# PROJECT COMMENTS

PROJECT NUMBER: SP2026-012  
PROJECT NAME: Site Plan for 276 Business Park  
SITE ADDRESS/LOCATIONS: 1375 STATE HIGHWAY 276, ROCKWALL, TX 75032

04/23/2026: SP2026-012; Site Plan for 276 Business Park

SITE PLAN			
276 BUSINESS PARK			
CITY OF ROCKWALL			
ROCKWALL COUNTY, TEXAS			
J CADLE SURVEY, ABS 0065, TRACT 2-5			
DATE	PROJECT NO	DRAWING SCALE	SHEET
4/16/26	CD25020	1" = 30'	SP

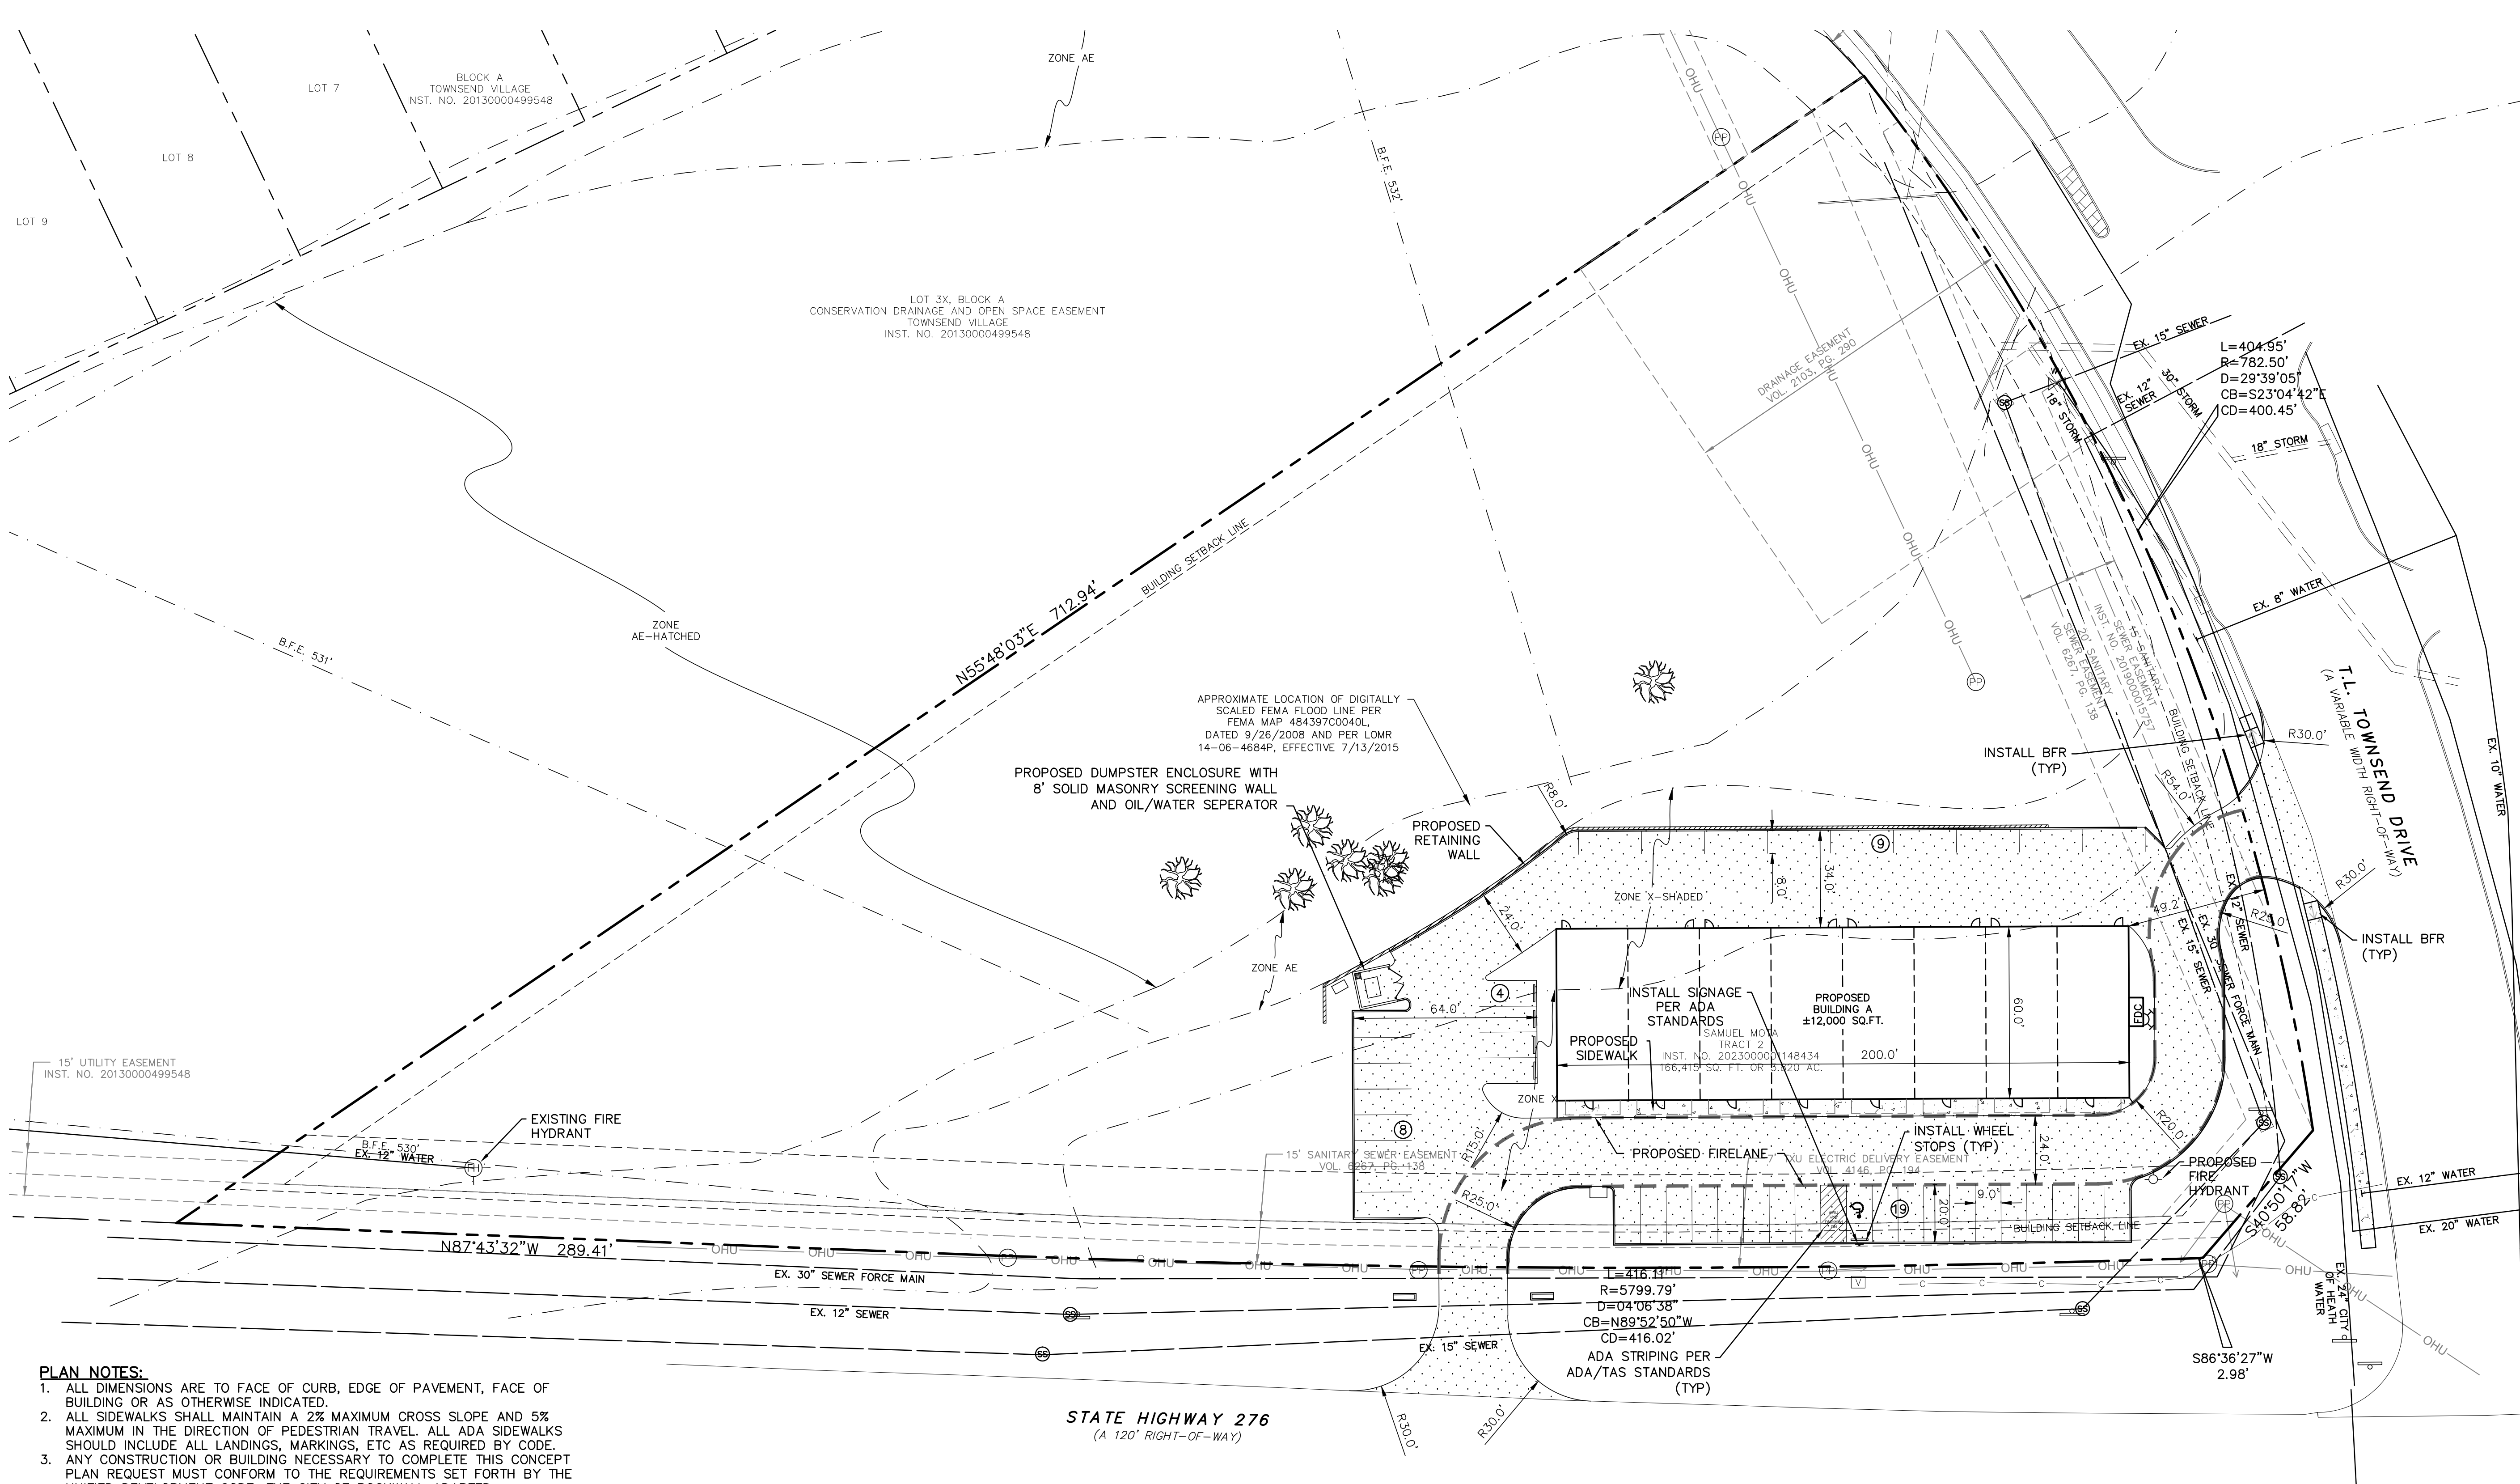
#### M.6 Site Plan

- 1) Indicate all perimeter dimensions of the site. (Subsection 03.04.B, of Article 11, UDC)
- 2) Indicate perimeter dimensions of the building (Subsection 03.04.B, of Article 11, UDC)

- 3) Indicate distances between the building and property lines. (Subsection 0.04.B, Article 11, UDC)
- 4) All overhead utilities shall be placed underground. (Subsection 06.02.H, Article 05, UDC)

- 5) A five (5)-foot sidewalk will be required along T.L. Townsend Drive and an eight (8) foot trail is required along SH-276. (Subsection 03.04.B, of Article 11, UDC)

- 6) Indicate the street centerline and any median breaks for both T.L. Townsend Drive and SH-276. (Subsection 03.04(B), Article 11, UDC)
- 7) Parallel Parking. Each parking space shall not be less than nine (9) feet in width and 22-feet in length. Maneuvering space will not be less than 24-feet. (Section 2.20(C)4, City of Rockwall Engineering Standards of Design and Construction)

- 8) General Retail uses require 1 parking space per 250 SF of building area. Please revise parking table.  $12,000/250 = 48$  parking spaces. (Subsection 0.01, Article 6, UDC)

- 9) Two (2) Handicap spaces are required for a total of 26-50 parking spaces. (Subsection 05.04(A), Article 06, UDC)
- 10) The parking on the west side of the building cannot extend past the front façade of the building. (Subsection 06.02(D), Article 05, UDC)

- 04/23/2026:
1. Site plan is required to show ex. and proposed water, sanitary sewer, and approximate location of detention
  2. If the dumpster enclosure along a retaining wall, retaining wall will have to be designed for the force of a fully loaded trash truck and the force exerted when forcefully placing dumpster down.
  3. No building, filling, or excavation in a flood plain unless a flood study have been approved by the City and a LOMR submitted and approved by FEMA
  4. Parallel parking is 9'x22'
  5. No landscape plantings or landscape berms will be allowed within these easements, you may need more room here to meet your landscape requirements.
  6. 425' spacing per TXDOT or TXDOT variance required
  7. No trees allowed within 10' of any public utility 10" in size or greater. No trees allowed here

Project	24111
Revision	C
Date	04/17/2026
Scale	
<b>A4.1</b>	
OF SHEETS

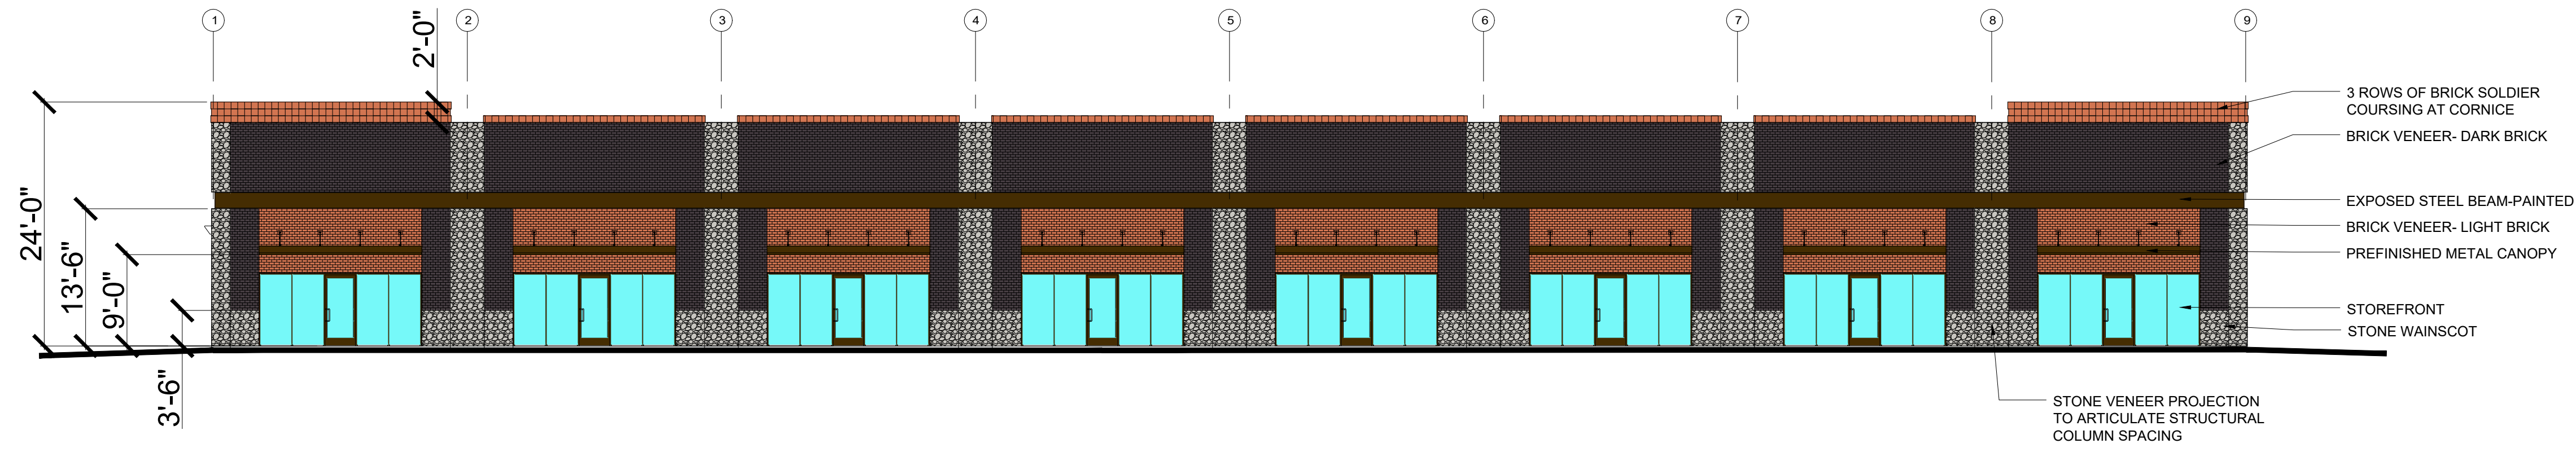
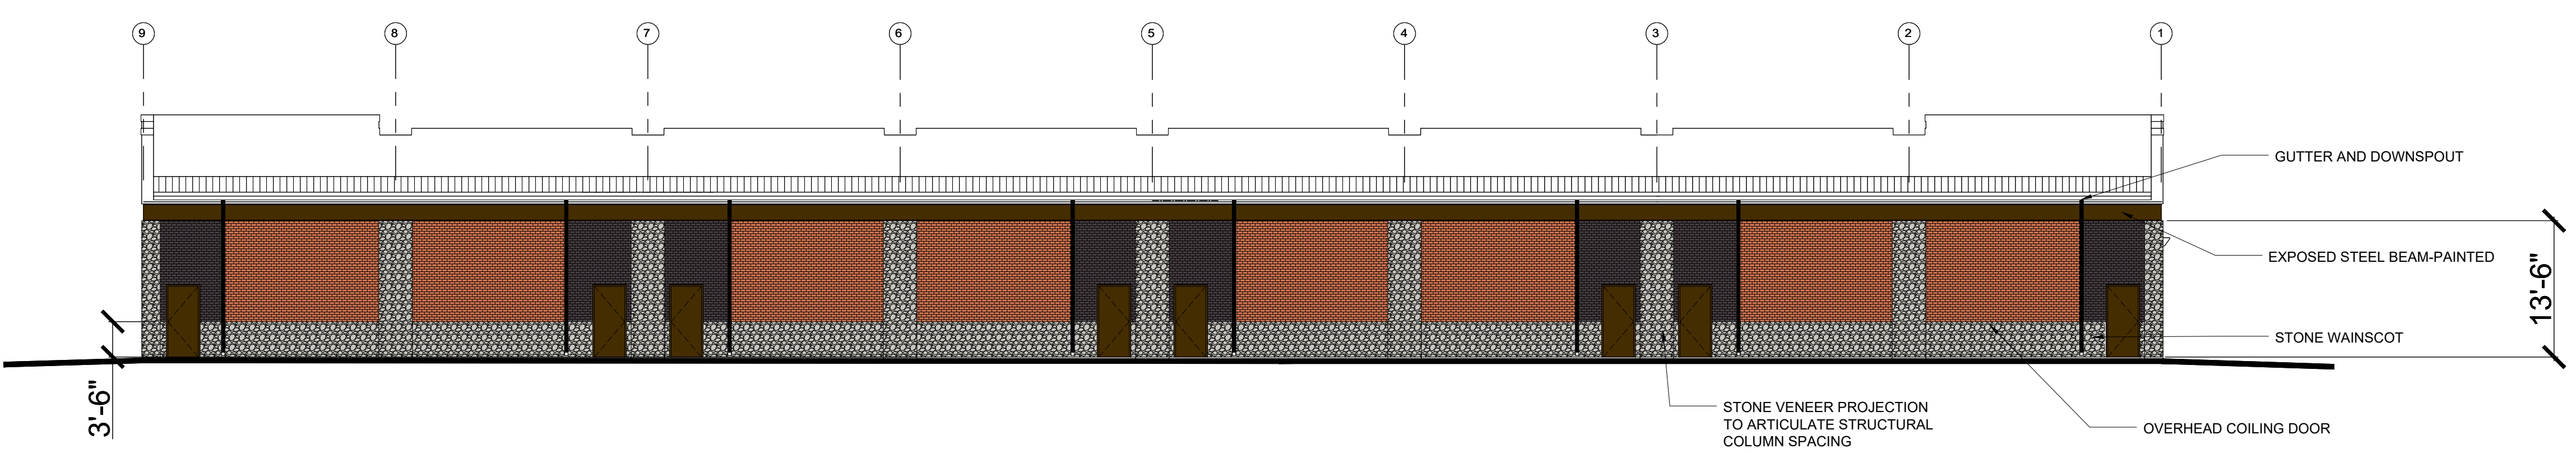
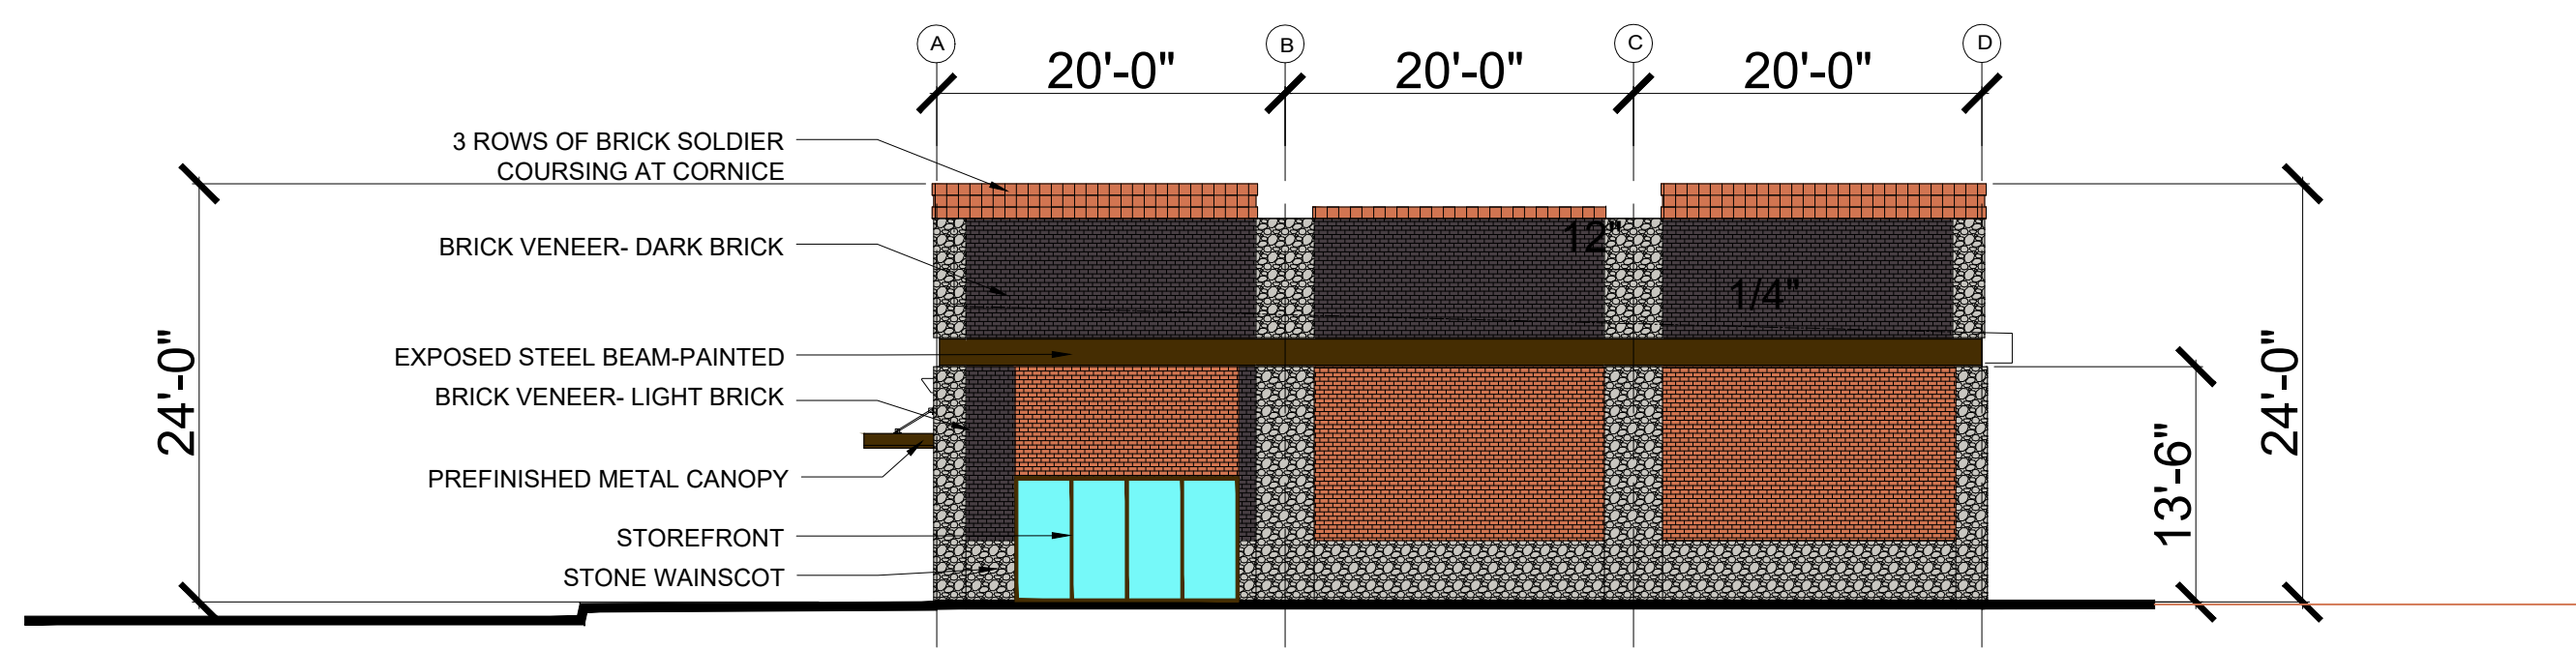
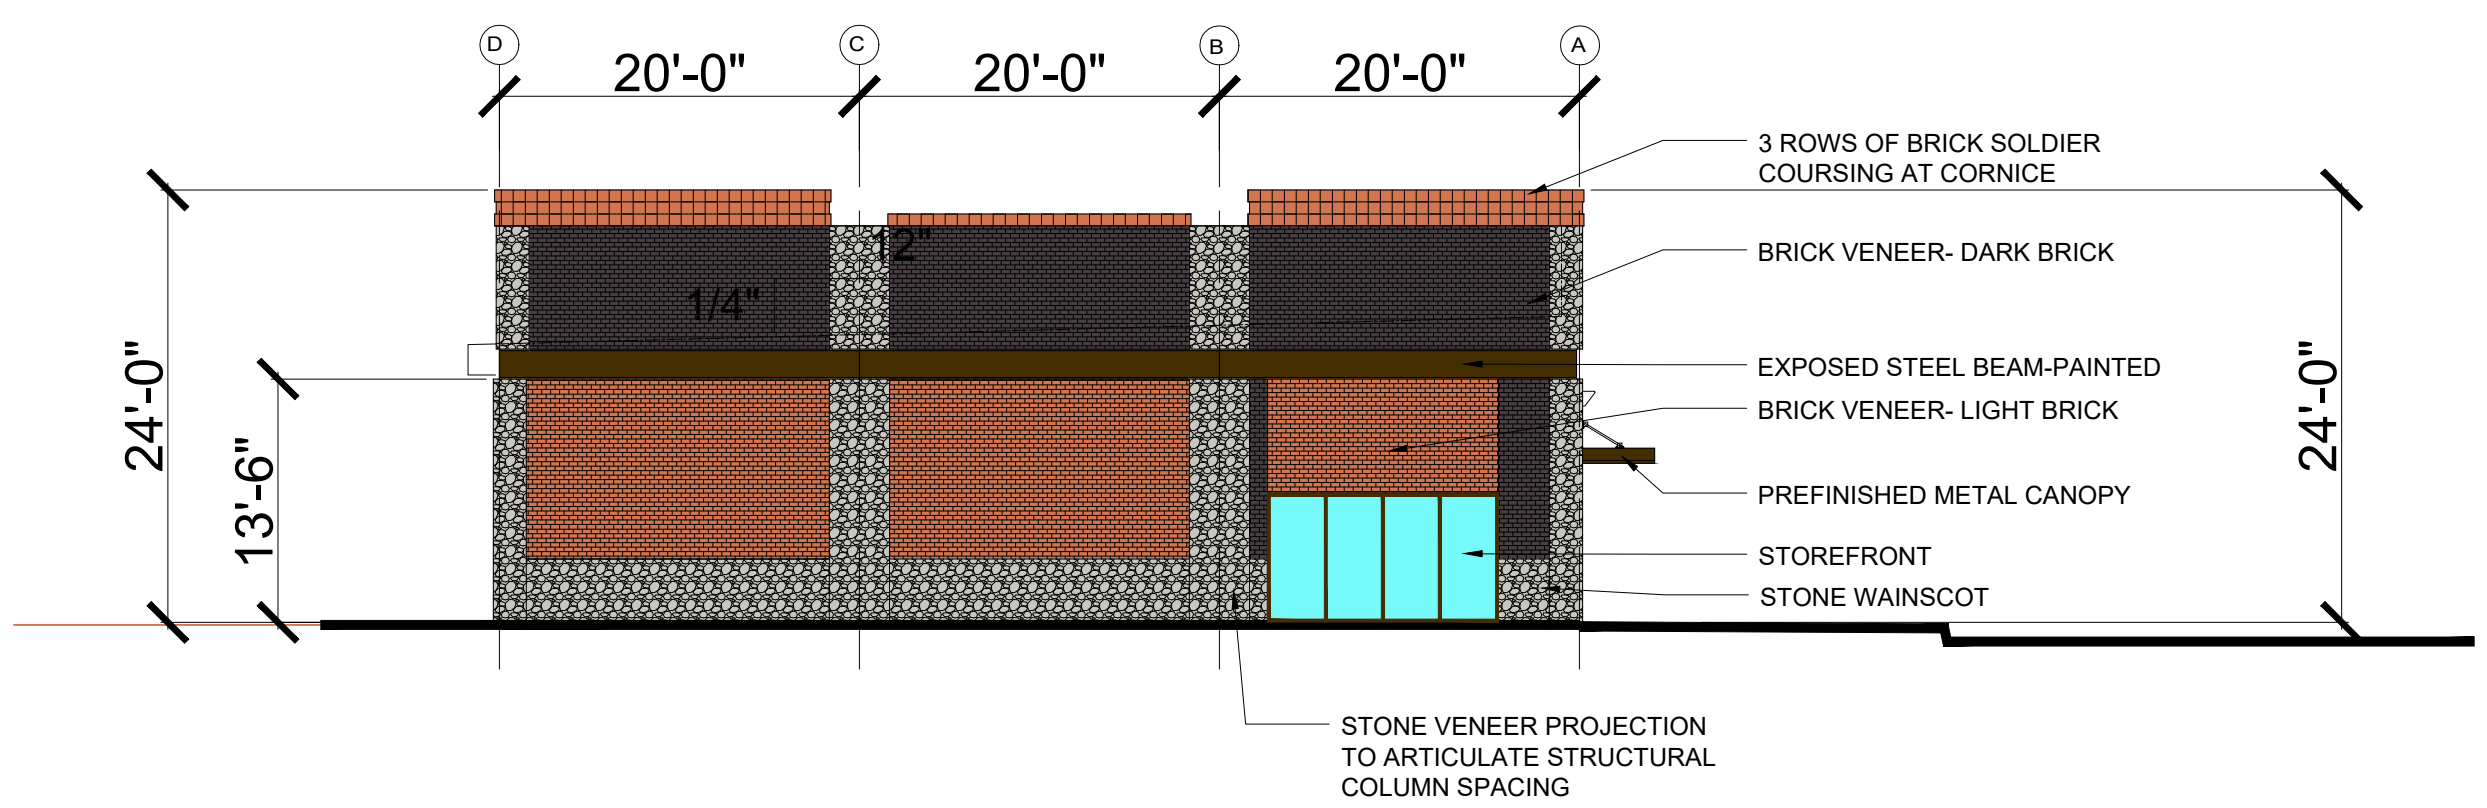
#### M.8 Building Elevations

- 1) Indicate the elevations that are adjacent to T.L. Townsend and SH-276.
- 2) Building does not meet four (4)-sided architecture requirements. Specifically, the following articulation is required for all four sides of the building:
  1. Wall Length cannot exceed 72 feet
  2. Minimum Secondary Entryway/Architectural Element Length is 18 feet
  3. The Minimum Wall Projection is 6.5 feet
  4. The Minimum Primary Entryway/Architectural Element is 36 feet
  5. The Minimum Projection height is 6.5 feet
  6. The Minimum Primary Entryway/Architectural length is 13.5 feet

This will require a variance from the Planning and Zoning Commission. (Subsection 06.02.C.5, of Article 05, UDC)

- 3) Parapets shall be extended back and finished on the backside, same as front. (Subsection 05.01.A.2, Article 05, UDC)
- 4) Indicate the parapet height. Parapets are required on all four sides of the building and will need to be shown that they will screen any RTUs on the building. (Subsection 01.05 (C), Article 05, UDC)
- 5) Provide a note indicating a self-latching gate on the dumpster. (Subsection 01.05.B, of Article 05, UDC)
- 6) The use of manufactured stone is a variance to the overlay district standards. (Subsection 06.02.C.a.1, of Article 05, UDC)
